**CERTIFICATE OF APPROPRIATENESS**

**Property:** 1405 Allston St, Lot 10, Block 154, Houston Heights Subdivision. The property includes a historic 2,156 square foot, wood frame single-family residence and a detached carport situated on a 6,600 square foot (50' x 132') interior lot.

**Proposal:** **Alteration:** Siding, windows, addition.

Side Wall Length and Insets (Addition and New Construction)

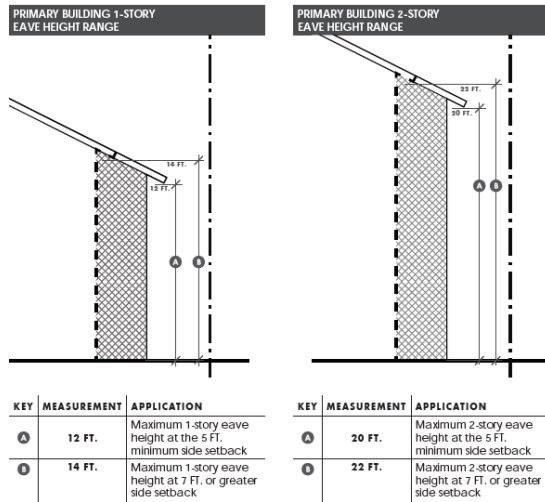
Inset on the south elevation but not on the north one.

Applicant is maintaining three corners as recommended by Heights Design Guidelines and adding a vertical trim board and a roof detail where the original corner was.

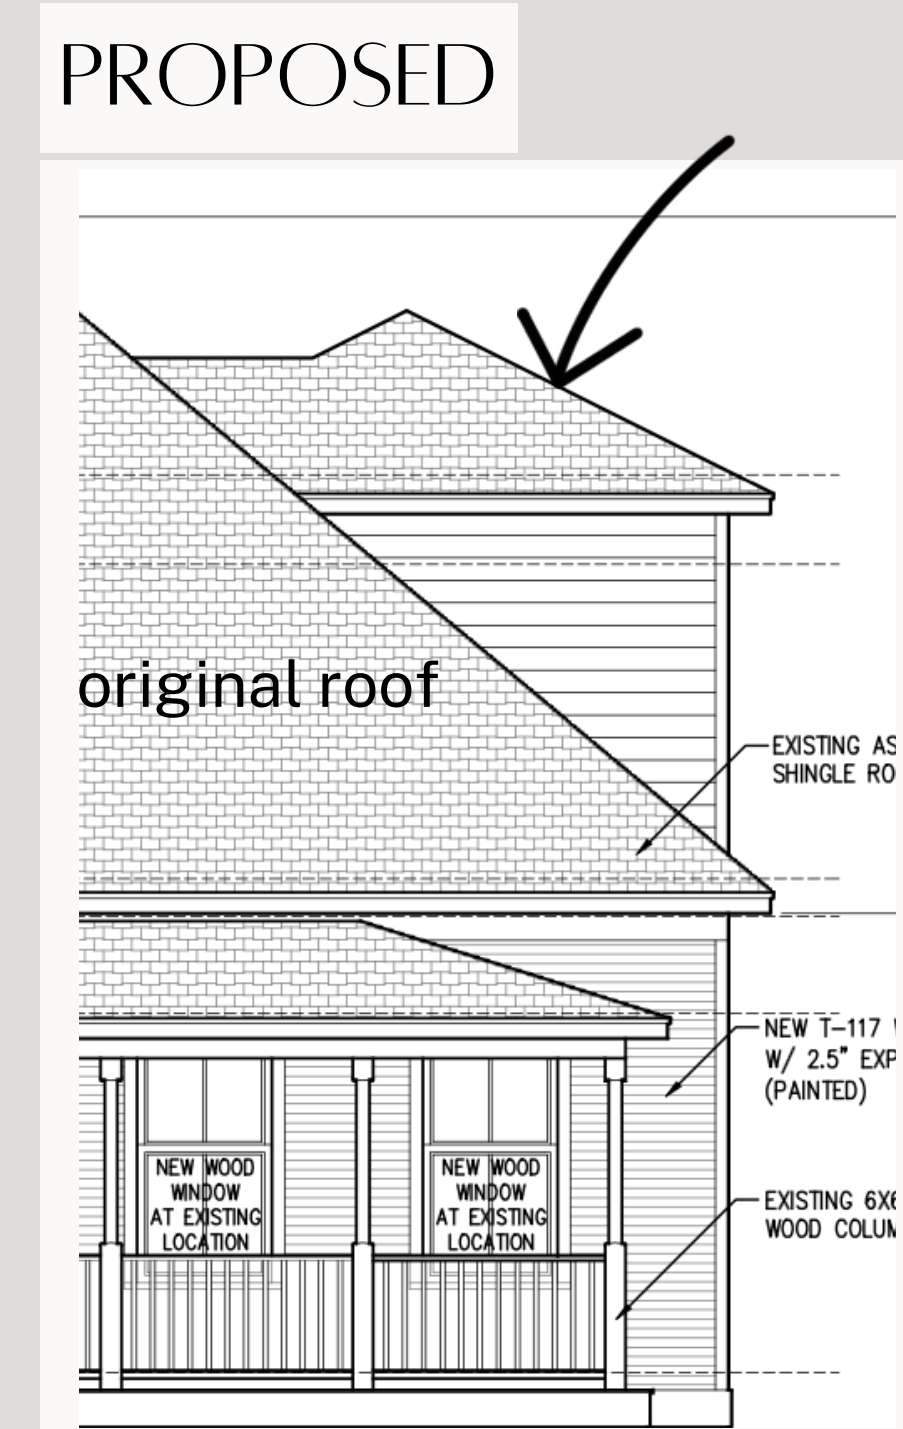
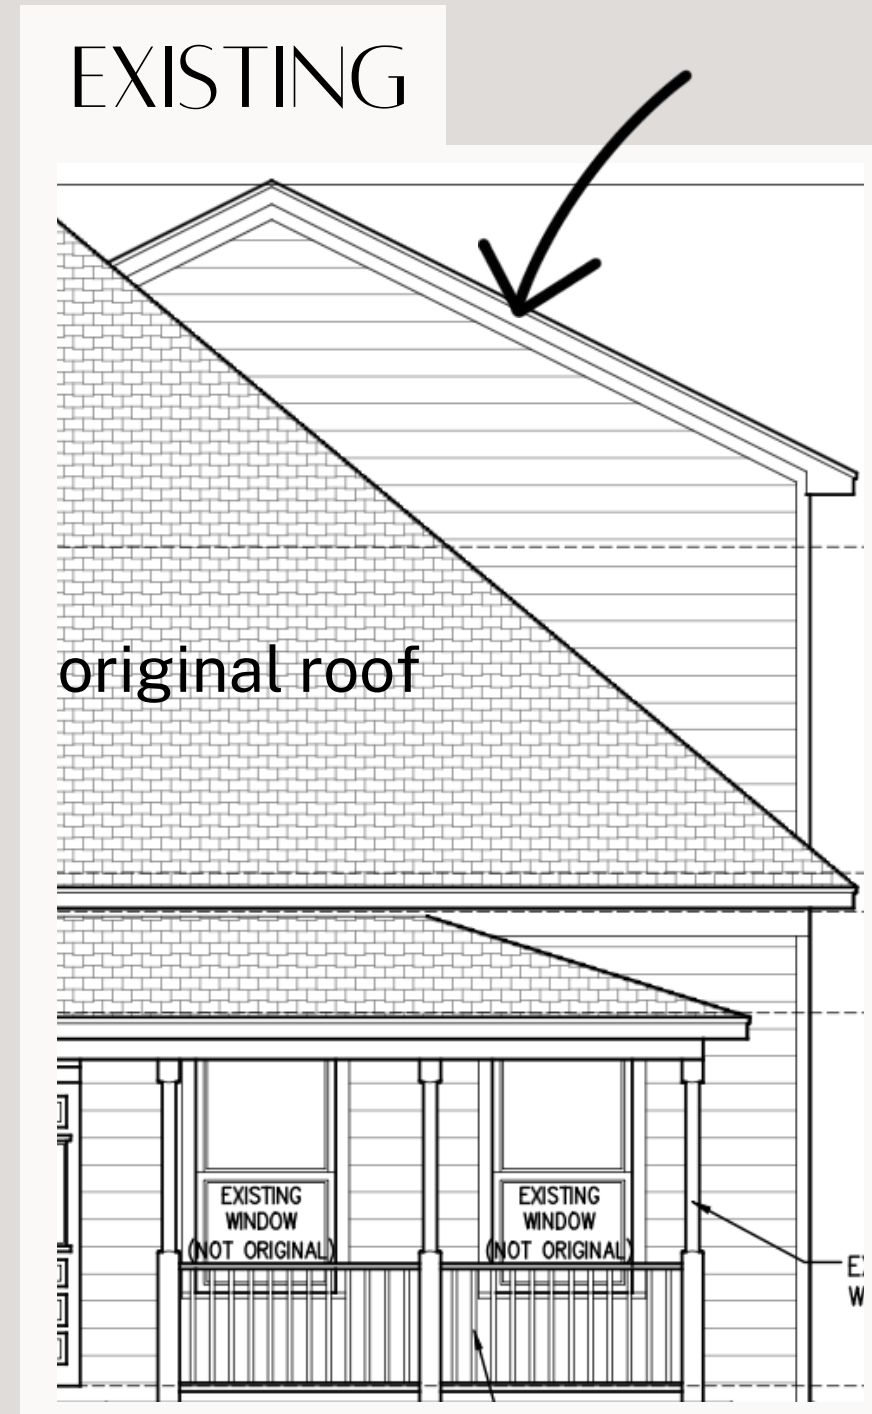
Keep the existing foot print but meet the FAR guidelines by creating attic space where the original attic was once located.

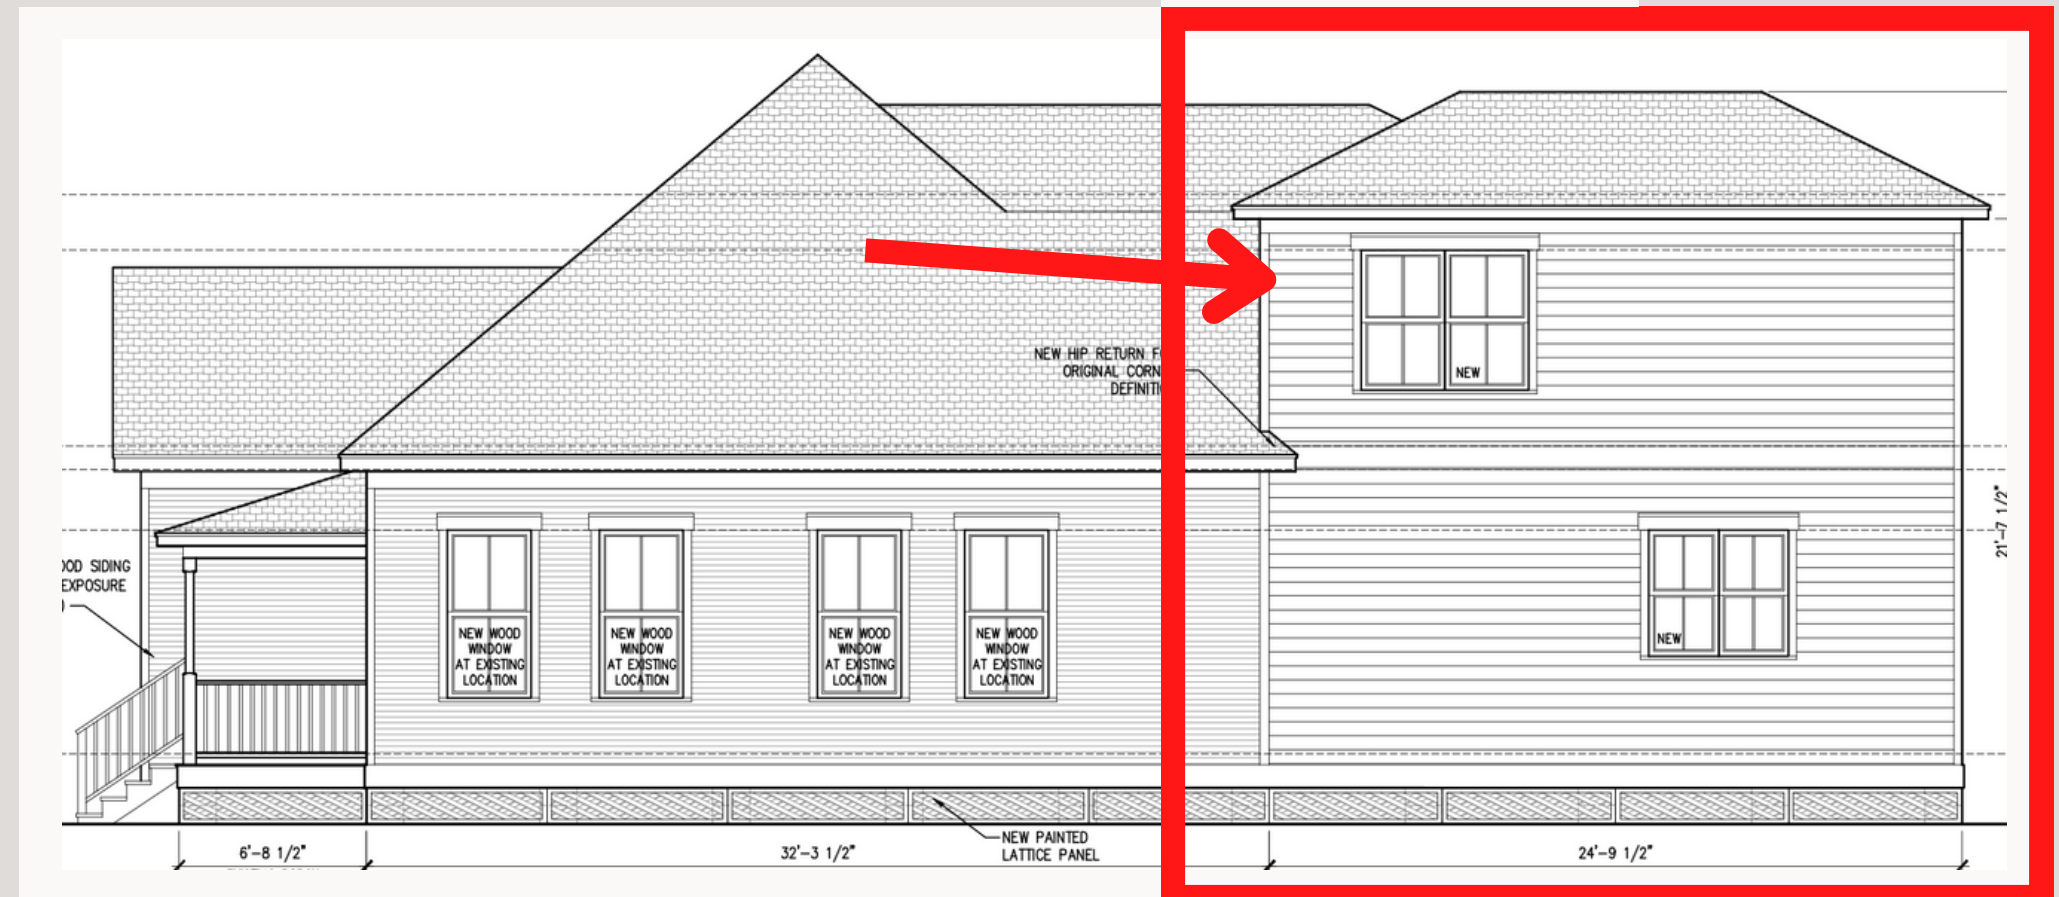
Keep the existing addition's north wall as-is with no 2ft inset, due to the following considerations...

(a trim piece to be added to differentiate the original home from the addition)
